Amphenol PCD

Engineering Change Request		ECR Number	R10544W
Initiator:	Tom	Date:	26.8.31
Part number description			
Item	K3 Code material part numbers	Note	
1	HVCON1 Series AC plug	Detailed model information see the attachment	
2	HVCON1&2 Series DC plug	Detailed model information see the attachment	
Reason of change:			
☐ Customer requirement (list the feasibility analysis of customer specification: _____)			
☐ Supplier request (list the PCR number: _____)			
☒ internal improvement ☐ corrective ☐ other			
Please describe here in detail:			
<u>ITEM1-2. Improve product waterproof performance.</u>			
Change level and impact assessment (Please tick in the appropriate position)			
Change level	Change content	Concerned area (Shenzhen, Hermosillo, Chennai)	Whether to notify the customer
Level 1	☐ Operator change		☐ It is not necessary to notify the customer for approval
	☐ Correct the clerical errors of the drawing, BOM, etc., and this change will not affect the production process

ITEM1-2.

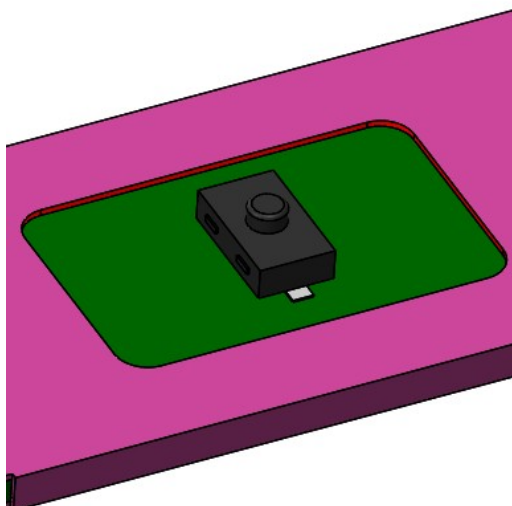
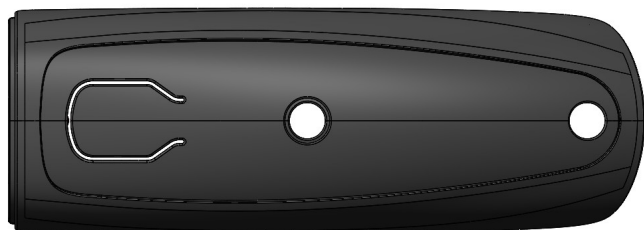
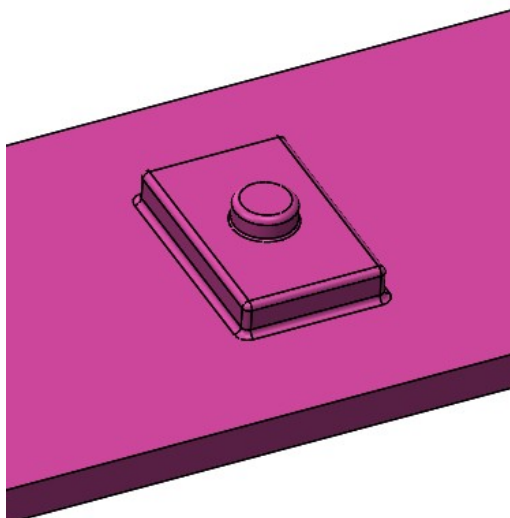
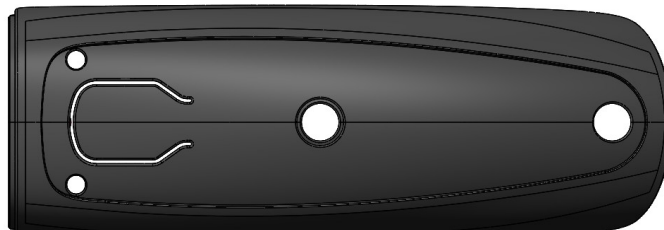
Adding small holes and switch protective covers improves the product's waterproof performance.
